Access Compliance Report

Public Rights-of-Way

(Curb Ramps)

Intersection ID: 42367	Main Street: FALCONCREST_DR	Cross Street: KESTRAL_RIDGE_DR	Location: E
ADA ID: AE483BE2990F	Ramp Type: PerpDiag	Initial Pass/Fail: Pass	Overall Compliance: No
Severity Score: 20			
Codes/Mitigation Info/Possible Solution		Field Measurements/Component Compliance

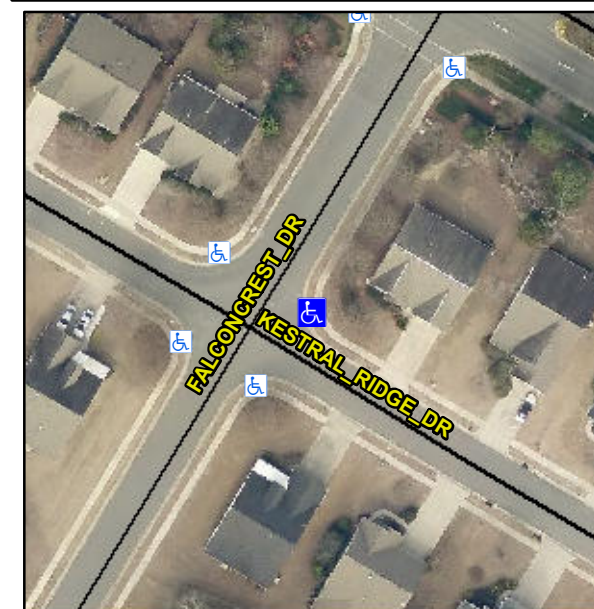
Not Found, R304.2.2, R305, R302.7.2

Compliance	Description	Data	Compliance	Description	Data
N/A	Ramp Length (in)	46.0	No	Ramp Slope (%)	8.4
Yes	Ramp Width (in)	59.0	Yes	Ramp XSlope (%)	0.6
N/A	Flare Type LT	Sloped	N/A	Flare Type RT	N/A
N/A	Flare Slope LT (%)	4.1	N/A	Flare Slope RT (%)	3.7
N/A	Flare Traversable LT?	No	N/A	Flare Traversable RT?	No
Yes	Landing Length (in)	48.0	No	DWS Provided?	No
Yes	Landing Width (in)	54.0	N/A	DWS Contrast?	No
Yes	Landing Slope (%)	1.9	N/A	DWS Length (in)	N/A
Yes	Landing X Slope (%)	0.2	N/A	DWS Full Width?	No
N/A	Landing Curb? (Y/N)	No	N/A	DWS Offset (in)	N/A
N/A	Shared Landing?	No			
Yes	Gutter Ponding?	No	Yes	Gutter Slope (%)	2.1
No	Gutter Lip Ht (in)	0.5	Yes	Gutter X Slope (%)	0.3
N/A	Painted X Walk1?	No	N/A	Painted X Walk2?	No
	X Walk 1 Direction	To NW		X Walk 2 Direction	To SW
N/A	X Walk 1 Width (in)	N/A	N/A	X Walk 2 Width (in)	N/A
	X Walk 1 Slope (%)	2.1		X Walk 2 Slope (%)	0.6
	X Walk 1 X Slope (%)	1.1		X Walk 2 X Slope (%)	1.4

Remove & Replace Curb Ramp With Two New Directional Ramps or Equivalent.
